FEDERAL ENERGY  
REGULATORY COMMISSION

FERC Project Nos. 2525,  
2595, 2522, 2546, 2560, and  
2581

The order modifying and approving the water quality monitoring plans for the Caldron Falls Hydroelectric Project (FERC Project No. 2525), the High Falls Hydroelectric Project (FERC Project No. 2595), the Johnson Falls Hydroelectric Project (FERC Project No. 2522), and the Sandstone Hydroelectric Project (FERC Project No. 2546), the Potato Rapids Hydroelectric Project (FERC Project No. 2560), and the Peshtigo Hydroelectric Project (FERC Project No. 2581) dated either September 14, 1998 or September 15, 1998 states that the licensee (Wisconsin Public Service Corporation, WPSC) shall determine the location of the monitoring equipment in consultation with the Wisconsin Department of Natural Resources (WDNR). If the licensee and the WDNR cannot agree on a location for the monitoring, the licensee shall file its recommendations, along with the WDNR comments, for Commission approval.

SUBJECT: Proposed Water Quality Monitoring Device Locations, FERC Project  
Nos. 2560, 2525, 2522, 2546, 2595, and 2581

Figure 2

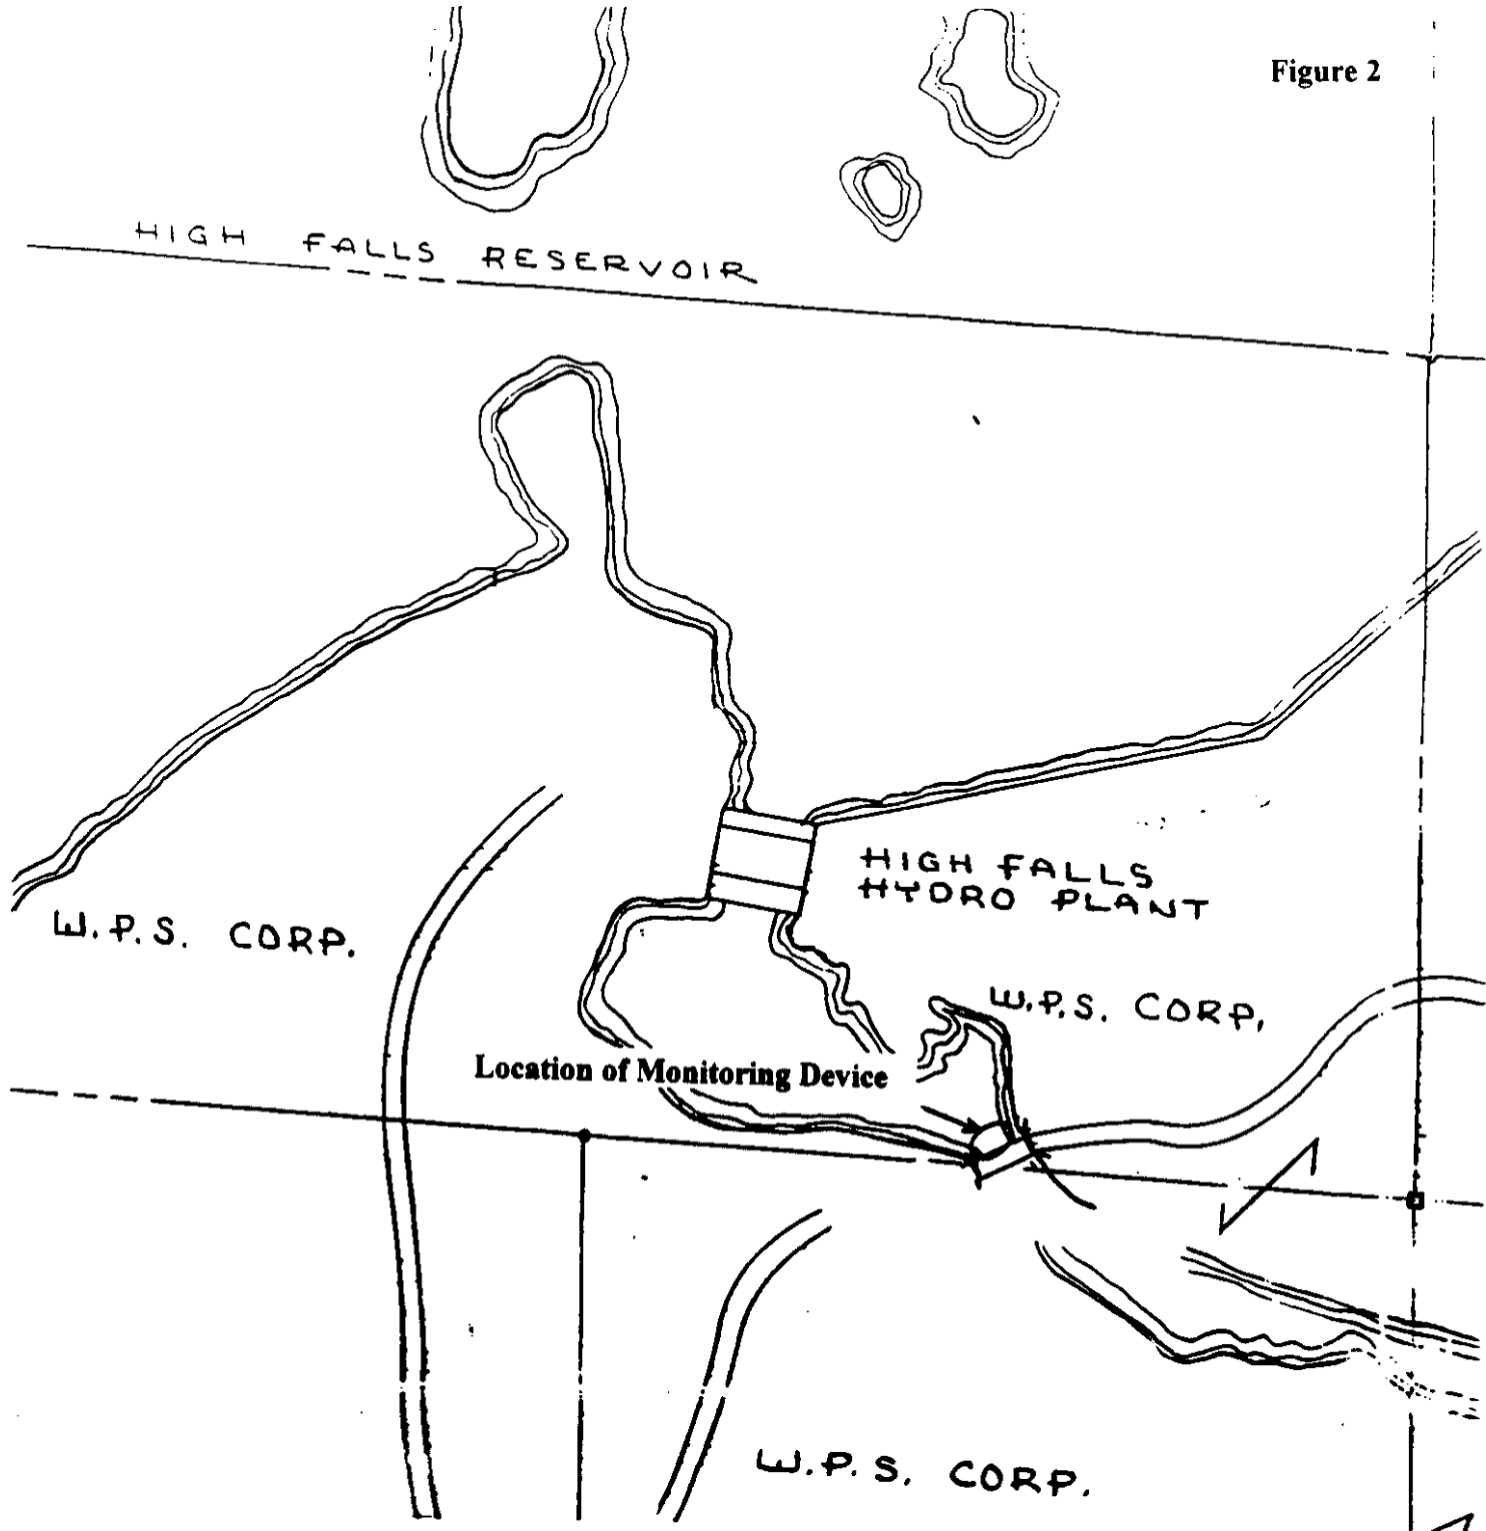
Figure 2 depicts the placement of the monitoring device in relation to the dam structure. As agreed upon in previous conversations with the WDNR, the downstream monitoring device at Caldron Falls will serve as the upstream monitoring device at the High Falls Project. The downstream monitoring device will be placed near the middle of the river and will be attached to the concrete column supporting the bridge. WPSC does not believe it is necessary to determine the exact location of the monitoring device through a site visit with the WDNR because the past consultation record has proven an agreement on the locations is unlikely. The exact placement of the monitoring device is influenced by safety, ease of access, and protection from vandalism and theft. These factors are apparently not considered by the WDNR. Therefore, WPSC is providing an approximate location in the recommendations that will provide a format (location within the stream, proximity to the dam, etc.) which allows the agency concerns about the quality of data to be addressed.

The location you are proposing for the water quality monitoring device below the High Falls Project appears to be in a reasonable location, however we would suggest that the exact location be selected with the agency personnel during a site visit.

The proposed location of the downstream monitoring device is near the middle of the river and is attached to the concrete column supporting the bridge. WPSC does not believe it is necessary to determine the exact location of the monitoring device through a site visit with the WDNR because the past consultation record has proven an agreement on the locations is unlikely. The exact placement of the monitoring device is influenced by safety, ease of access, and protection from vandalism and theft. These factors are apparently not considered by the WDNR. Therefore, WPSC is providing an approximate location in the recommendations that will provide a format (location within the stream, proximity to the dam, etc.) which allows the agency concerns about the quality of data to be addressed.

Figure 3

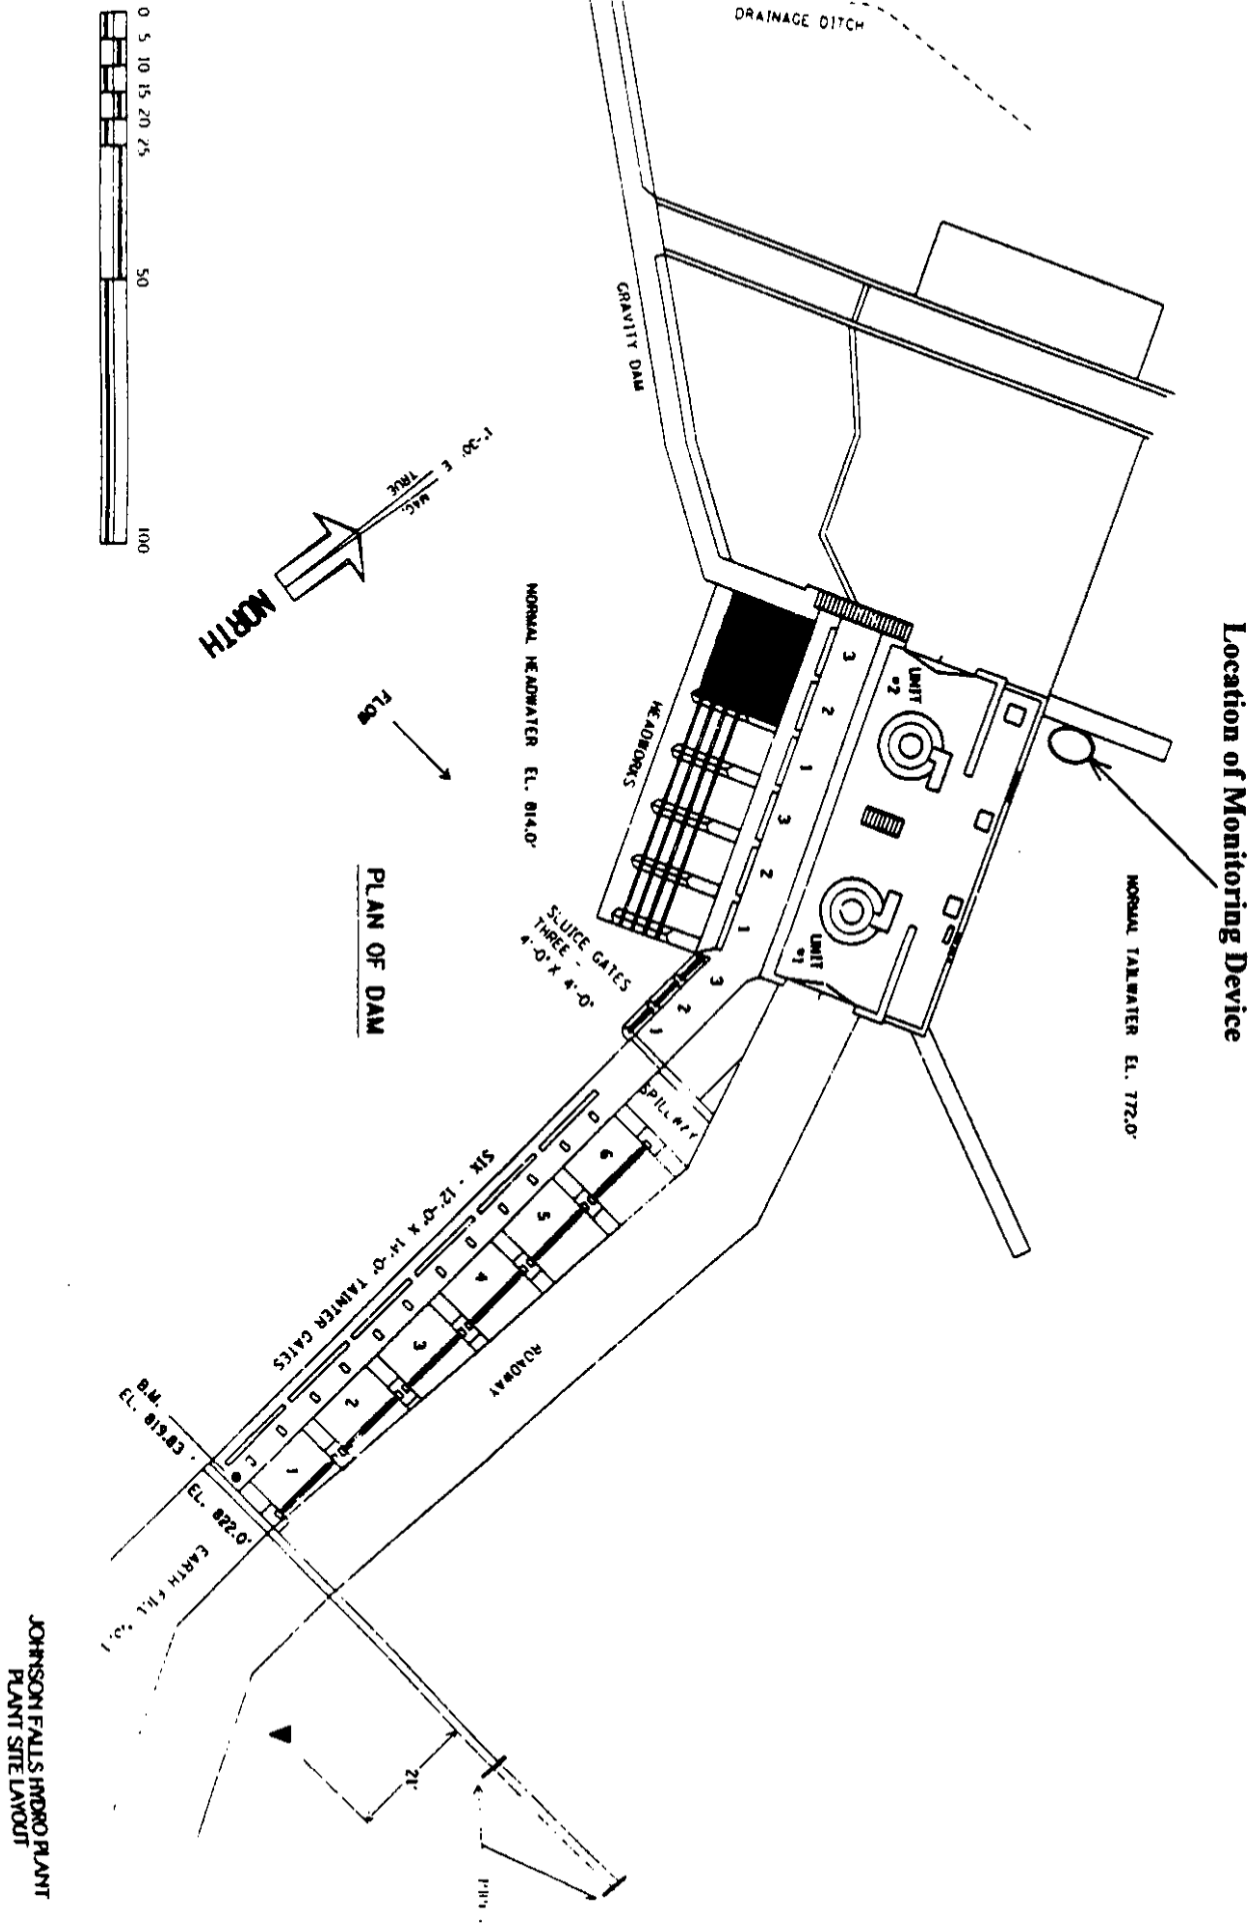
Figure 3 depicts the placement of the monitoring device in relation to the dam structure. As agreed upon in previous conversations with the WDNR, the downstream monitoring device at High Falls will serve as the upstream monitoring device at the Johnson Falls Project. The location of the downstream monitoring device will remain the same as the location utilized for the relicensing water quality monitoring. The structure for retaining the water quality monitoring device remains in place and requires no modification for the proposed location. The proposed location is in the tailwater outfall and is attached to the powerhouse structure itself. WPSC does not believe it is necessary to determine the exact location of the monitoring device through a site visit with the WDNR because the past consultation record has proven an agreement on the locations is unlikely. The placement of the monitoring device is influenced by safety, ease of access, and protection from vandalism and theft. These factors are apparently not considered by the WDNR. Therefore, WPSC is providing an approximate location in the recommendations that will provide a format (location within the stream, proximity to the dam, etc.) which allows the agency concerns about the quality of data to be addressed.

We would suggest that the exact location for the placement of the water quality monitoring device be selected with the agency personnel during a site visit. The location proposed may be acceptable, however we would prefer to check this out during a site visit.

The proposed location of the downstream monitoring device will remain the same as the location utilized for the relicensing water quality monitoring. The structure for retaining

the water quality monitoring device remains in place and requires no modification for the proposed location. The proposed location is in the tailwater outfall and is attached to the powerhouse structure itself. WPSC does not believe it is necessary to determine the exact location of the monitoring device through a site visit with the WDNR because the past consultation record has proven an agreement on the locations is unlikely. The exact placement of the monitoring device is influenced by safety, ease of access, and protection from vandalism and theft. These factors are apparently not considered by the WDNR. Therefore, WPSC is providing an approximate location in the recommendations that will provide a format (location within the stream, proximity to the dam, etc.) which allows the agency concerns about the quality of data to be addressed.

Figure 4

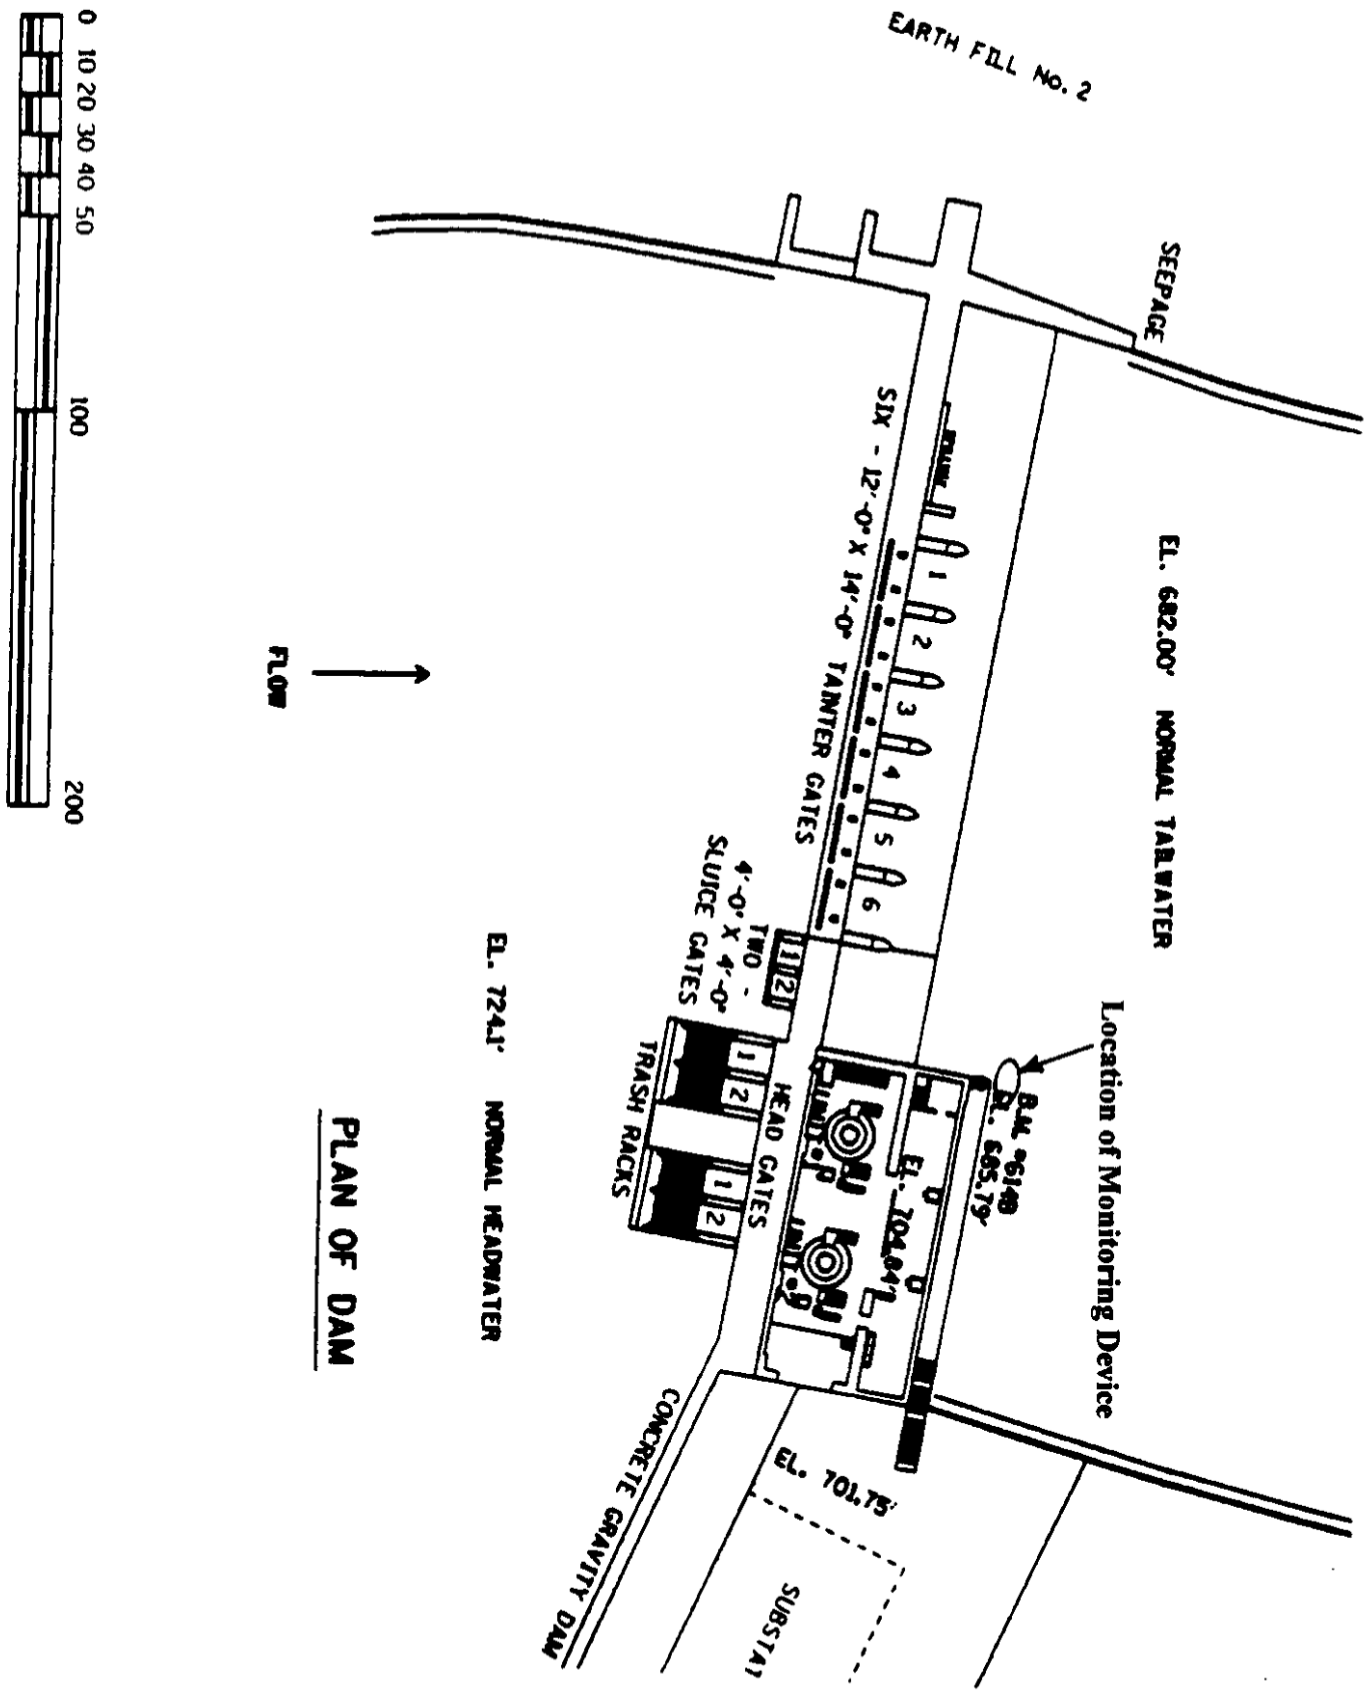
Figure 4 depicts the placement of the monitoring device in relation to the dam structure. As agreed upon in previous conversations with the WDNR, the downstream monitoring device at Johnson Falls will serve as the upstream monitoring device at the Sandstone Rapids Project. The location of the downstream monitoring device will remain the same as the location utilized for the relicensing water quality monitoring. The structure for retaining the water quality monitoring device remains in place and requires no modification for the proposed location. The proposed location is in the tailwater outfall and is attached to the powerhouse structure itself. WPSC does not believe it is necessary to determine the exact location of the monitoring device through a site visit with the WDNR because the past consultation record has proven an agreement on the locations is unlikely. The placement of the monitoring device is influenced by safety, ease of access, and protection from vandalism and theft. These factors are apparently not considered by the WDNR. Therefore, WPSC is providing an approximate location in the recommendations that will provide a format (location within the stream, proximity to the dam, etc.) which allows the agency concerns about the quality of data to be addressed.

We would suggest that the exact location for the placement of the water quality monitoring device be selected with the agency personnel during a site visit. The location proposed may be acceptable, however we would prefer to check this out during a site visit.

The proposed location of the downstream monitoring device will remain the same as the location utilized for the relicensing water quality monitoring. The structure for retaining the water quality monitoring device remains in place and requires no modification for the proposed location. The proposed location is in the tailwater outfall and is attached to the powerhouse structure itself. WPSC does not believe it is necessary to determine the exact location of the monitoring device through a site visit with the WDNR because the past consultation record has proven an agreement on the locations is unlikely. The exact placement of the monitoring device is influenced by safety, ease of access, and protection from vandalism and theft. These factors are apparently not considered by the WDNR. Therefore, WPSC is providing an approximate location in the recommendations that will provide a format (location within the stream, proximity to the dam, etc.) which allows the agency concerns about the quality of data to be addressed.
